project **Stanwell New Projects Office**
Switchyard Road,
Stanwell, QLD, 4702

title **Section Details - Facade - Entries**

title Plan Details - Facade

1.2.4 DOCUMENT REVIEW The reviewer shall review the documents submitted by the contractor to ensure that they are complete and accurate. The reviewer shall also ensure that the documents are in accordance with the contract requirements. The reviewer shall provide a written report of the review to the contractor within the specified time frame.	
A Reviewed by Contractor	B Reviewed by Consultant
C Reviewed by Employer	D Reviewed by Architect
Normal Kesejahteraan Date: 17/12/2025	
 Inhabiti Inhabiti Australia Pty Ltd

title **Section Details - Facade -**
External

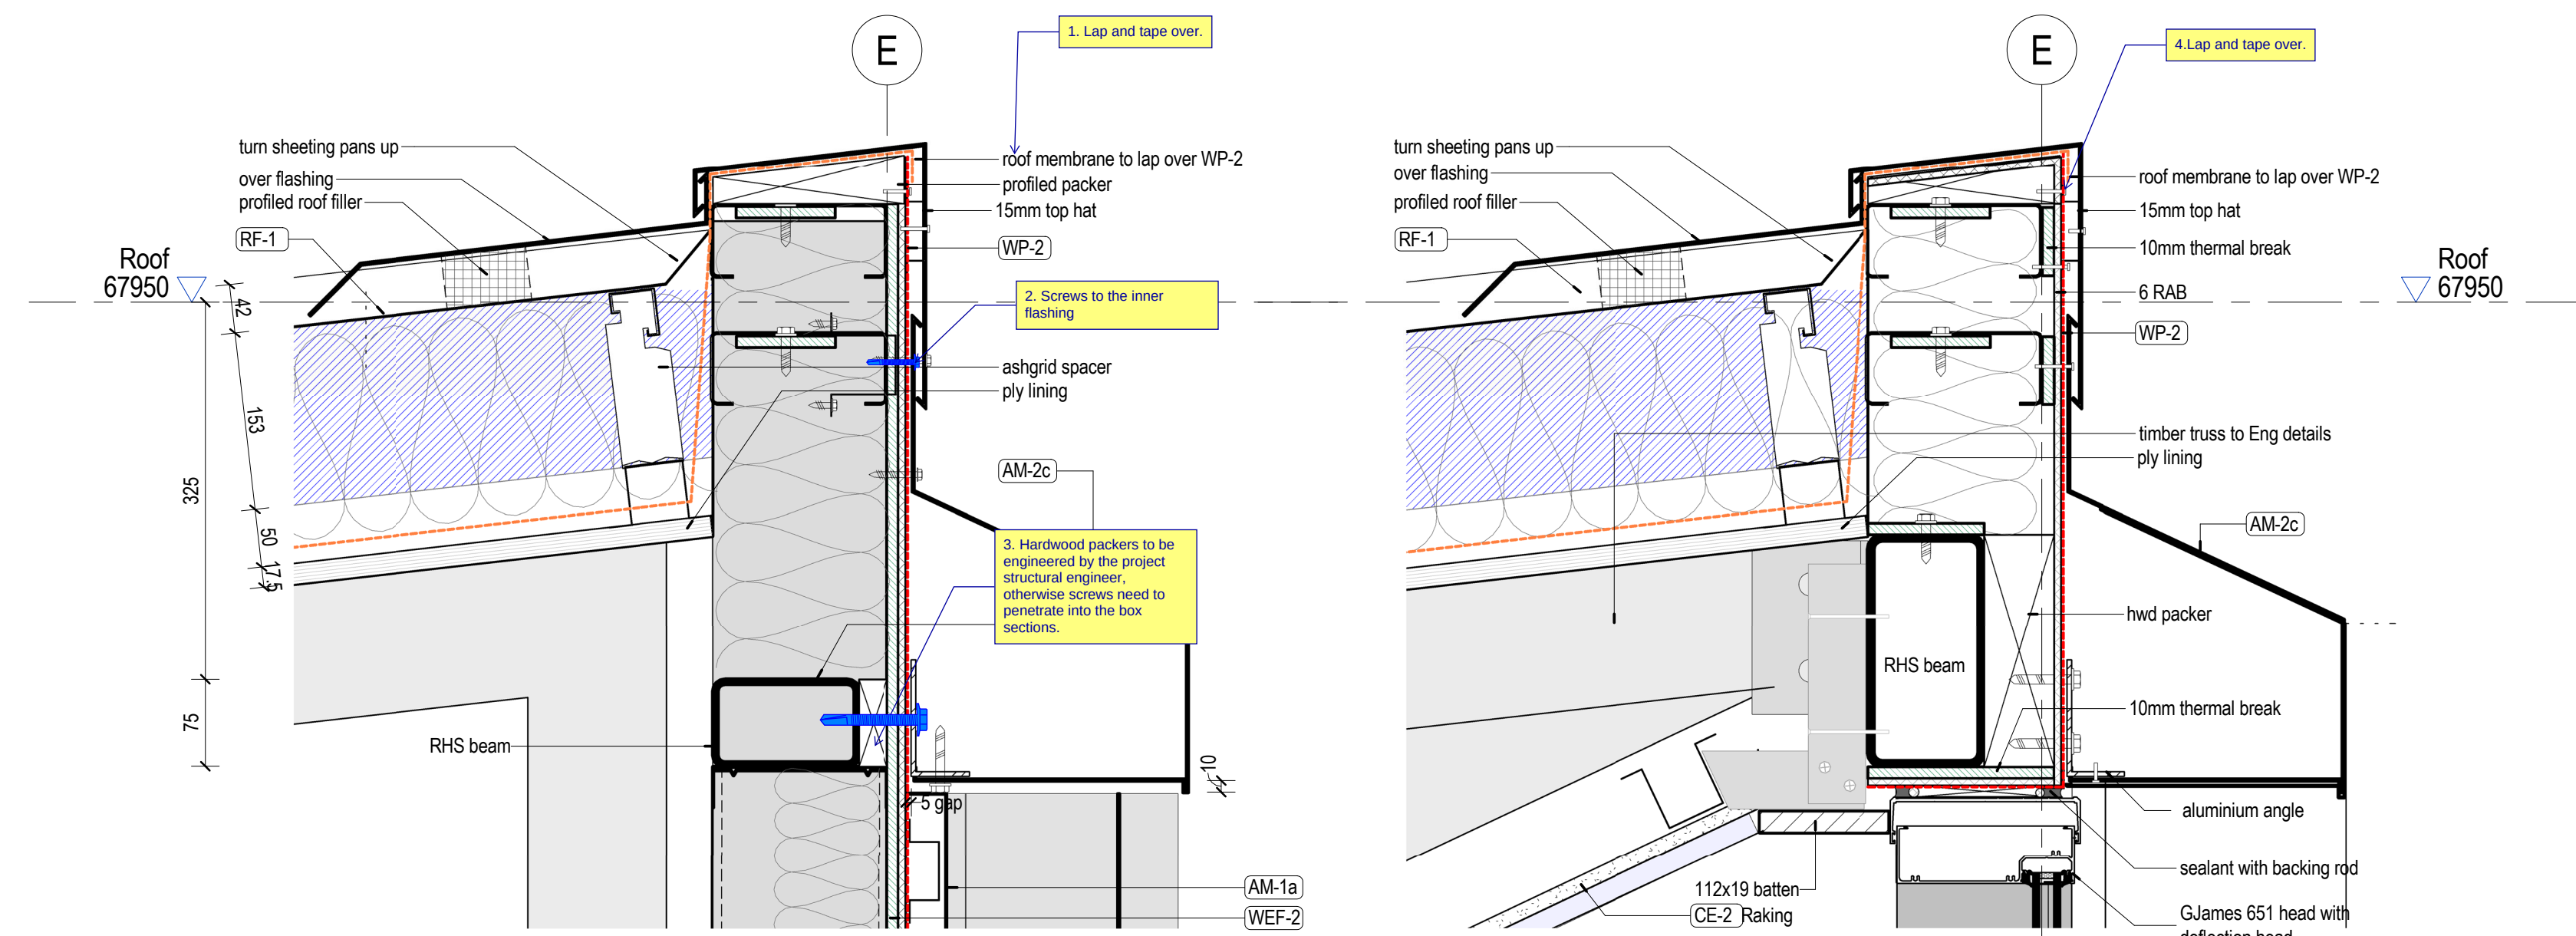
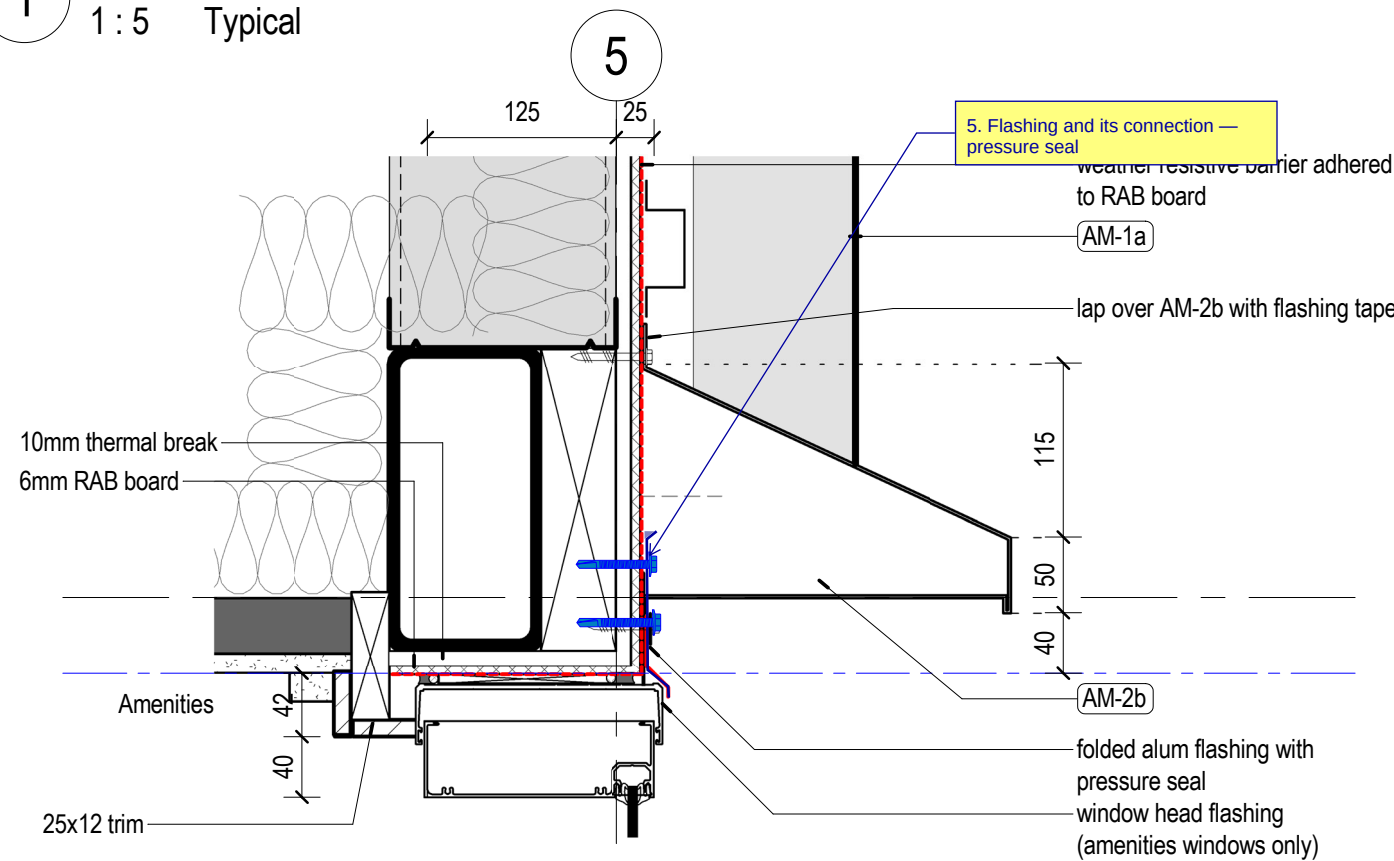
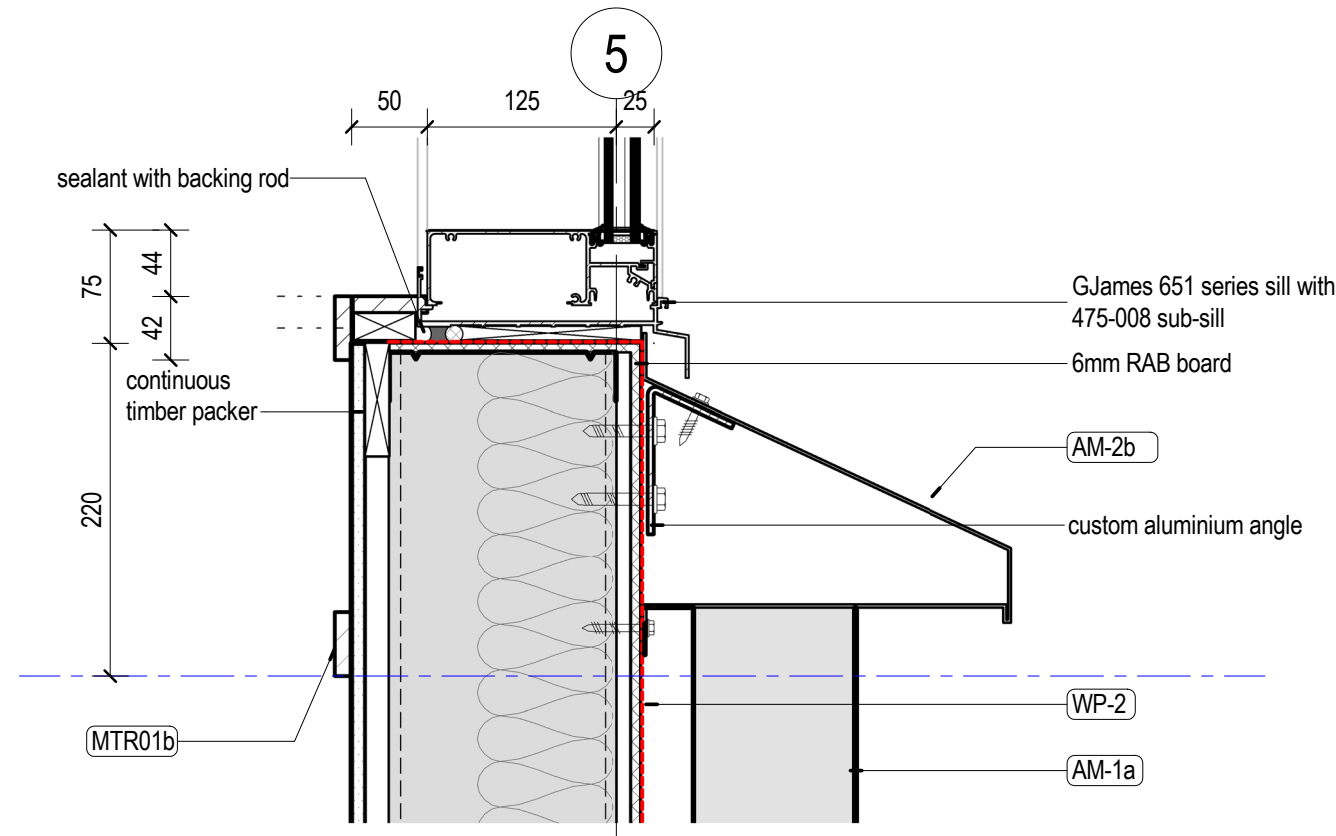
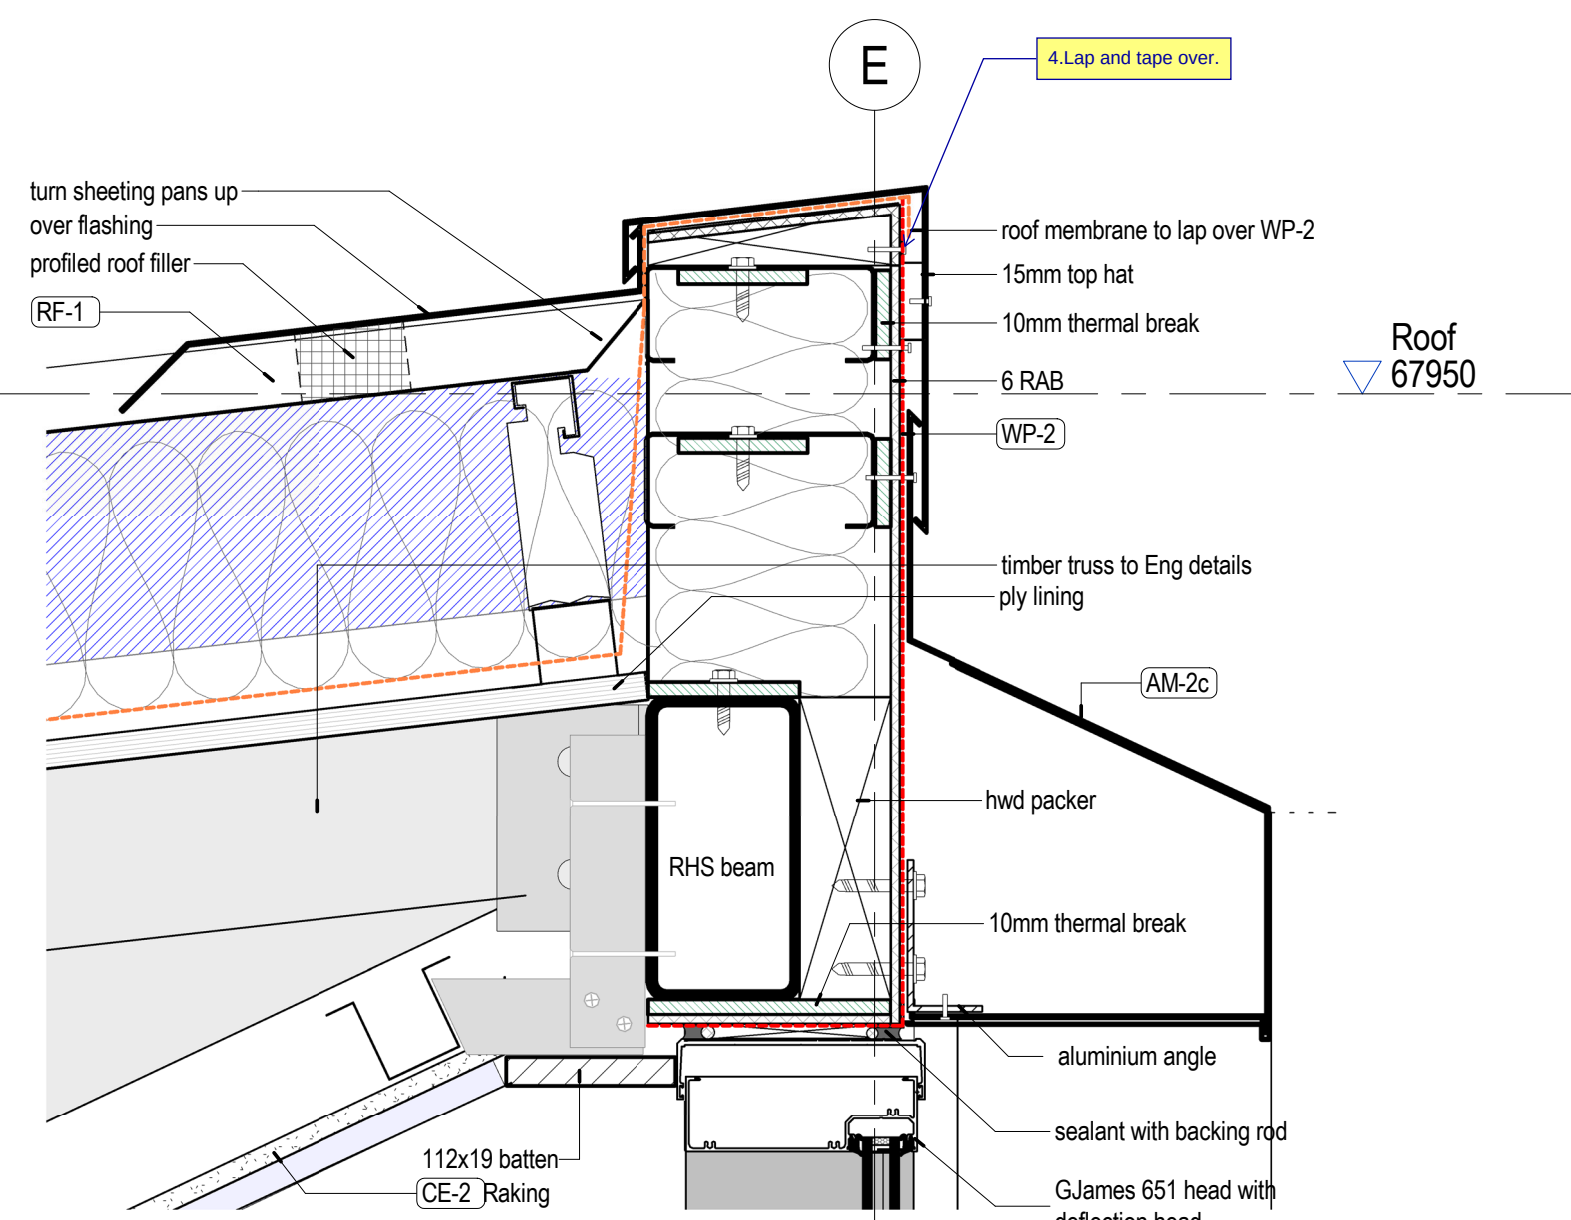
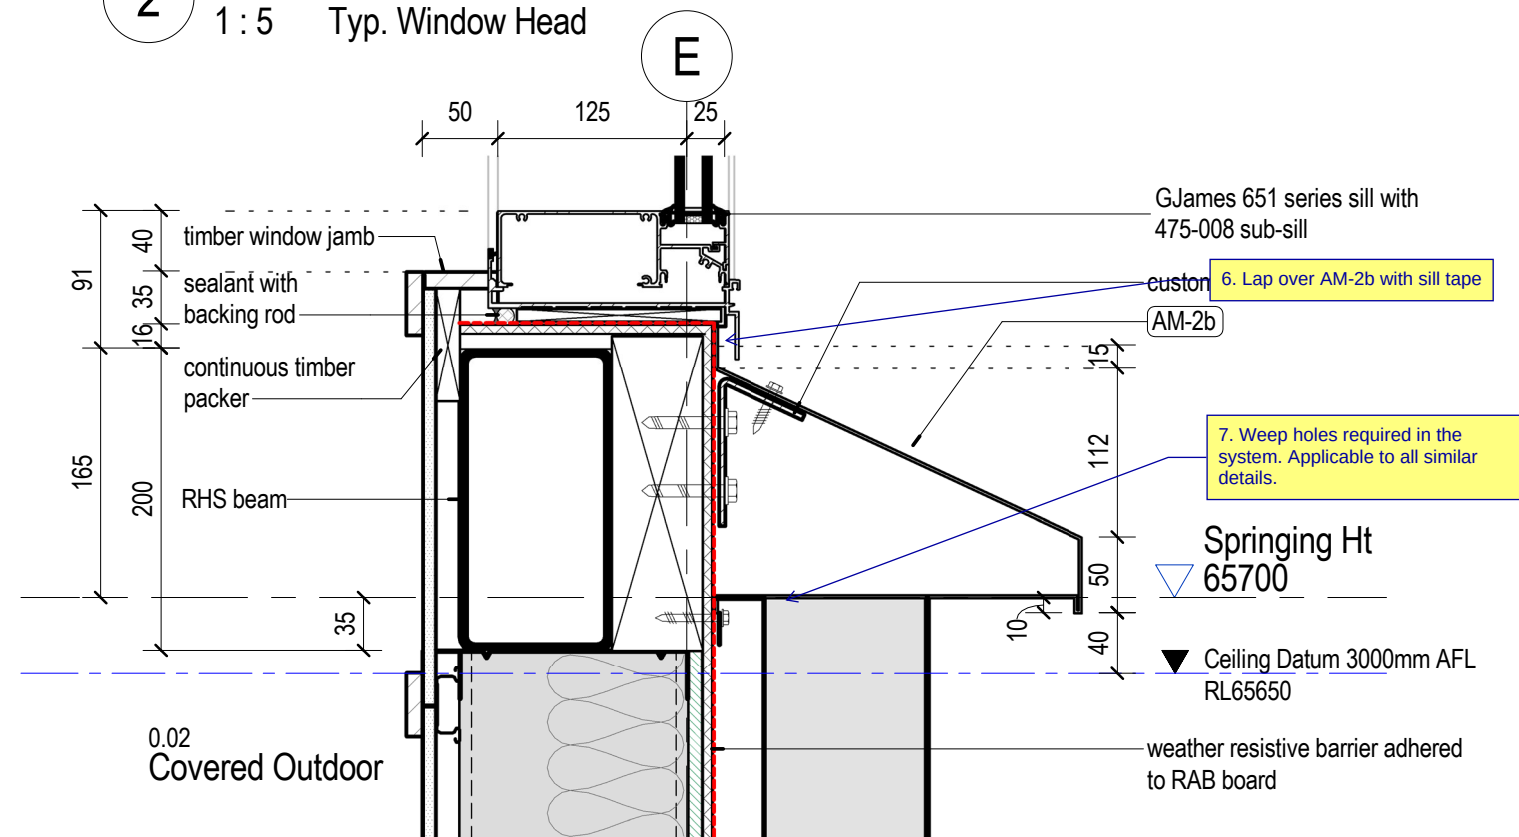
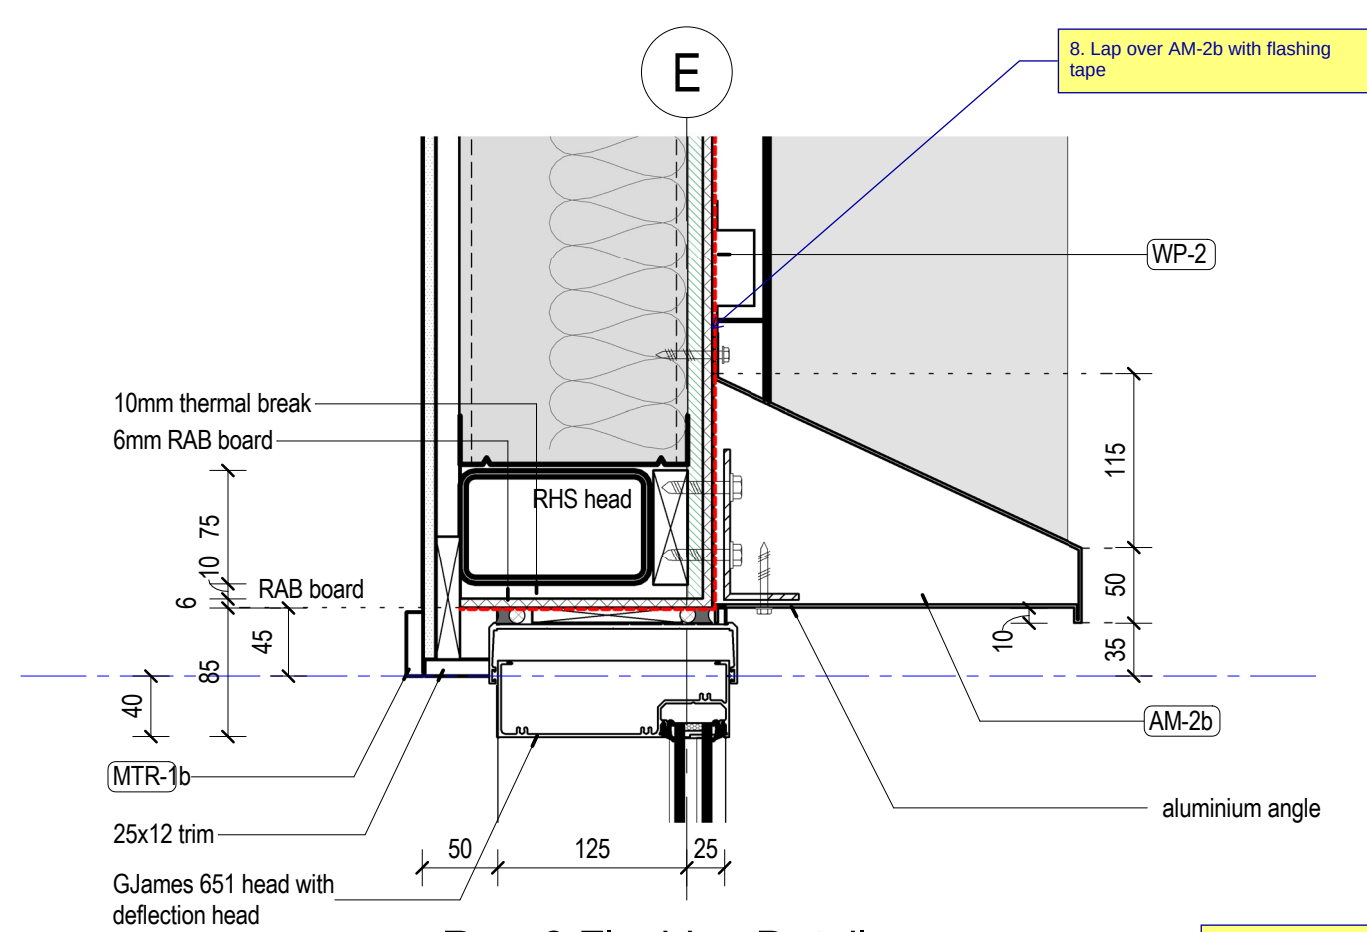
Notes:
1. All comments are applicable to similar details.
2. Membrane is shown in the architectural facade drawings below, however, specialised membranes are required at window reveals, including window sills, lap joints, and membrane terminations. Refer to the Inhabit F&P1 PBD8. Where information is not available, liaise with the product supplier, architect, and facade consultant.

3. Glazing and its interface details need to be reviewed as part of the shop drawings for FP1.4 verification.
4. The inhabit weatherproofing mark-ups on the architectural drawings are to be read in conjunction with the Inhabit F&P1 PBD8.

5. The aluminium sill flashing shall be installed with end dams at each end and fully sealed at corners and at vertical steel post interfaces. The flashing shall be continuous and wrap around the steel posts. Junctions shall be verified by water hose testing.

6. For all screw installations between the timber/aluminium-framed cladding and the substrate, apply a blob of sealant prior to installing the screw, and seal the screw heads afterwards. Stainless steel screws/anchors are to be used.

7. The following items shall be inspected and agreed during the first panel installation:
a. Lap over AM-2b with sill tape (at the top leg)
b. Weep holes within the system

c. Drainage within AM-2b
